**STAFF REPORT**  
**(One-Step Final Plat)**

**CASE NUMBER:** SUB 2007-92 – MAIZE SCHOOL SOUTH CAMPUS ADDITION

**VICINITY MAP**

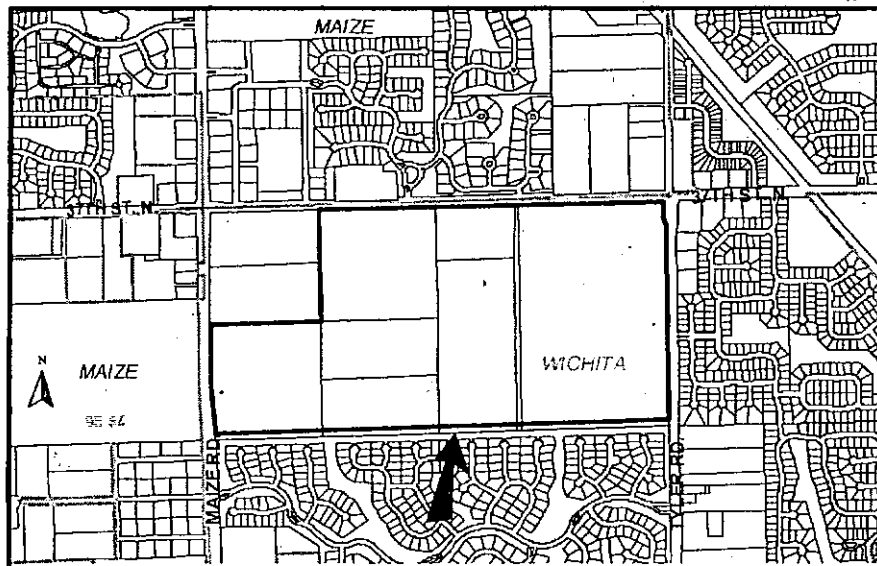
- C. City Engineering needs to comment on the status of the applicant's drainage plan.
- D. The plat proposes three openings along Tyler, three openings along Maize, and six openings along 37<sup>th</sup> St. North. Traffic Engineering requests that the face of the plat specifies that all access points shall be placed in accordance with Access Management Standards. Access controls need to be denoted at the corner of 37<sup>th</sup> St. North and Tyler. The site plan denotes an additional opening along Tyler that needs to be included on the final plat tracing.

- E. The plat's text shall note the dedication of the streets to and for the use of the public.
- F. The two lots shall be included within one block.
- G. The standard language regarding vacation statutes need to be referenced.

- H. Reserve A needs to address utilities.
- I. County Surveying advises that a benchmark datum is needed.
- J. The plat's text shall include reference to "lots and a block" in the owner's certificate.

- K. In accordance with the KS Wetland Mapping Conventions under the Memorandum of Understanding between the USDA-NRCS; USEPA; USACE; and USF&WS, this site has been identified as one with potential wetland hydrology. The US Army Corps of Engineers (USACE) should be contacted (316-322-8247) to have a wetland determination completed.

- L. In accordance with the plat's text, Fox Ridge Development Company is responsible for ownership and maintenance of Reserve A. The restrictive covenant associated with Reserve A will need to be signed by Fox Ridge Development Company.

- M. Provisions shall be made for ownership and maintenance of the proposed reserves. The applicant shall either form a lot owners' association prior to recording the plat or shall submit a covenant stating when the association will be formed, when the reserves will be deeded to the association and who is to own and maintain the reserves prior to the association taking over those responsibilities.

- N. On the final plat tracing, the MAPC signature block needs to reference "M.S. Mitchell, Chair"
- O. The plat's text shall include language that a drainage plan has been developed for the plat and that all drainage easements, rights-of-way, or reserves shall remain at established grades or as modified with the approval of the applicable City or County Engineer, and unobstructed to allow for the conveyance of stormwater.
